ADDENDUM NO. 02

Project Name: Santa Fe Solid Waste Management Agency
Caja del Rio Landfill – Cell 5B Liner Construction

Request for Bid No.: '14/43/B

LEACHATE RISER CAP

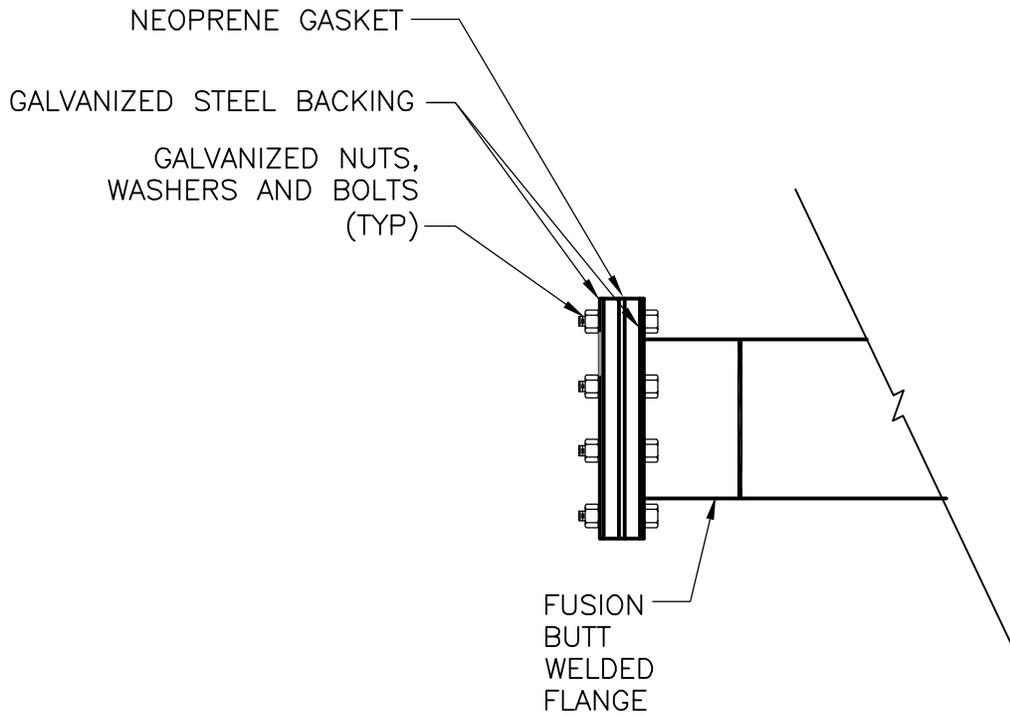
2. Sheet CD-2, Leachate Collection System Details
 - a. Detail A, Leachate Riser: Insert a call-out for "Detail F" to the riser cap shown in this detail; add the **attached** "Detail F, Leachate Riser Cap" to this sheet.

8. **Question/Comment:** Will Domestic Material be required for this project?
Response: Domestic Material is not a requirement for this project.
9. **Question/Comment:** Plan sheet CD-2: Detail A shows what looks like an HDPE Flange Adapter with a Blind Flange, but this is not called out. Please provide a detail for this?

10. **Question/Comment:** Addendum No. 1, B, 2 adds note to "replace all six existing riser caps." Please provide detail. Are these Blind Flanges, slip caps, screw caps, etc.?

30. **Question/Comment:** Addendum No. 1, dated June 30, 2014, Item 6b on page A1-2 calls out "riser pipe caps". Is this phrase meant to represent the blind flange shown on the riser details provided on CD-2?

Response: Please see the attachment for the leachate riser cap detail shown in Detail A, CD-2. See also revisions to Sheet CD-2, Leachate Collection System Details, above.

Response: The "riser pipe caps" represent the blind flange as shown in the Addendum 02 attachment. See also revisions to Sheet CD-2, Leachate Collection System Details, above.

1. BLIND FLANGE BOLTS SHALL BE TORQUED TO MEET MFR RECOMMENDATION. DO NOT OVERTIGHTEN.
